Charlotte-Mecklenburg Planning Department

SUBJECT: Administrative Approval for Petition No. 2008-105 Phillips Development & Realty, LLC

Attached is the revised site plan for the petition above. This request allows the modification of the proposed site plan as listed below. Since these changes do not alter the intent of the development and meets the requirements of the Charlotte Zoning Ordinance Section 6.207 <u>Alterations to Approval</u>, minor changes, I am administratively approving this plan. Please use these plans when evaluating requests for building permits and certificates of occupancy.

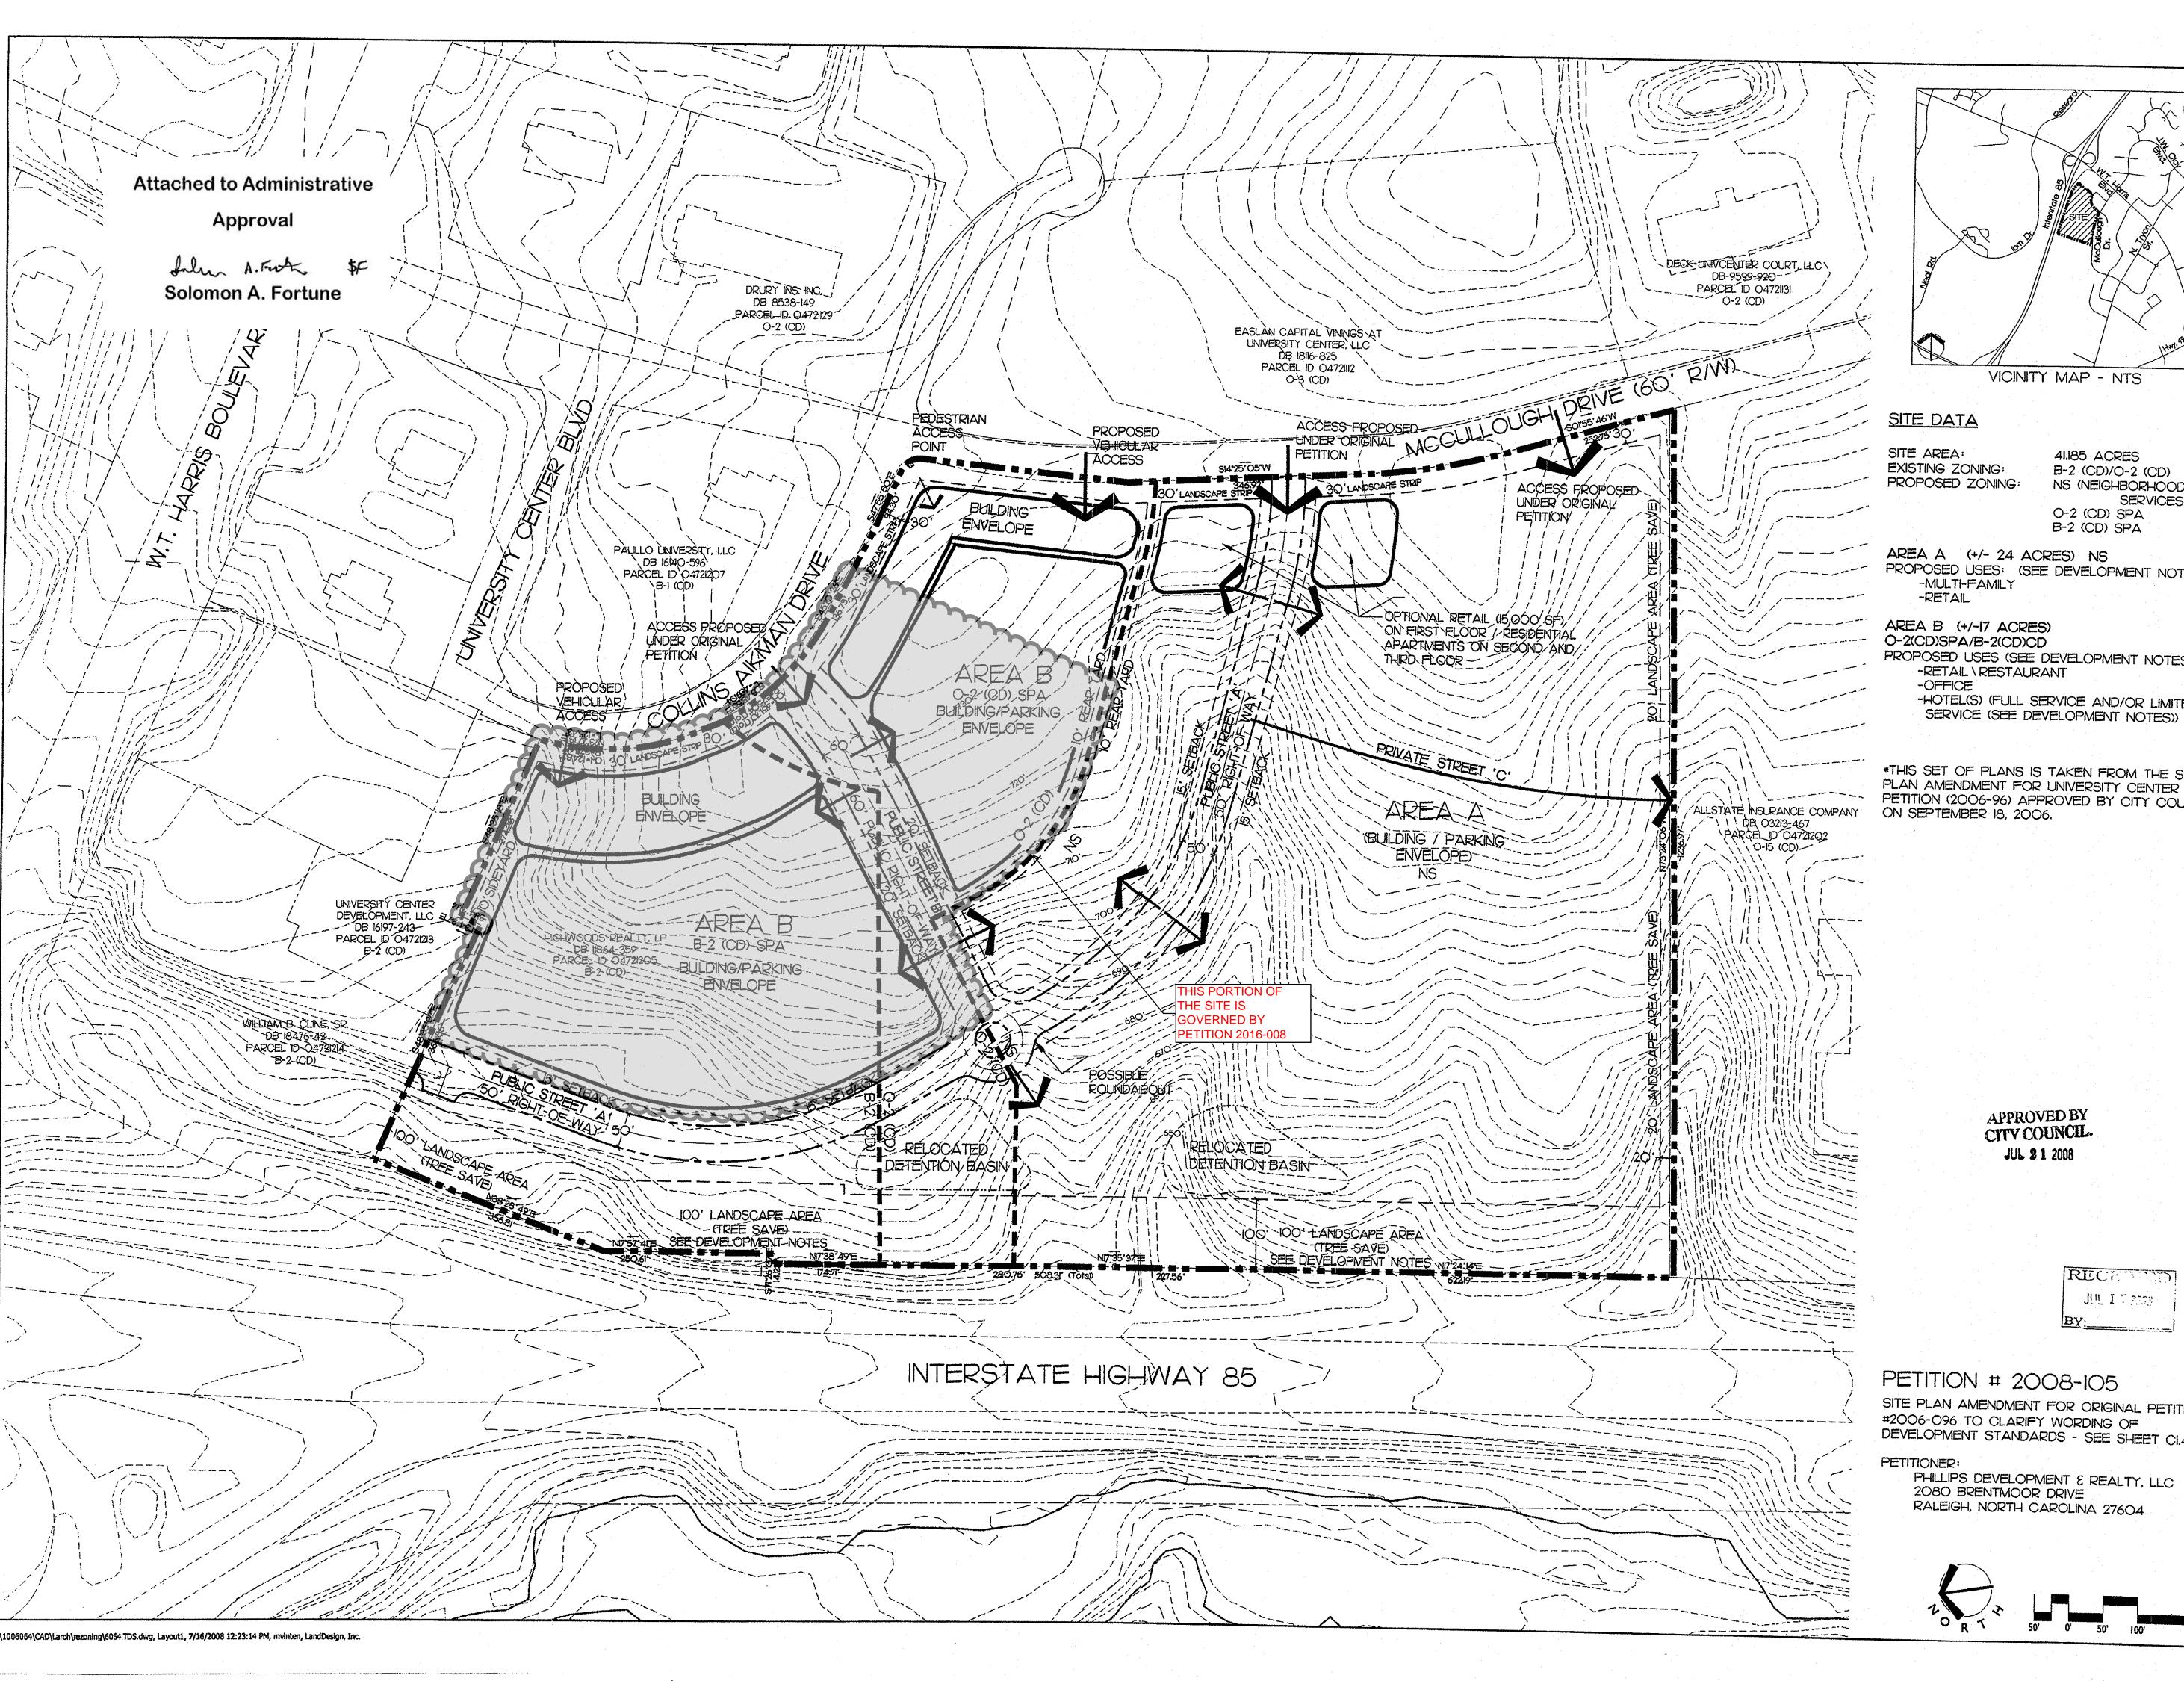
- Reduction of rights for the remaining portion of Area B.
- Note added that a portion of the site is now governed by petition 2016-008.
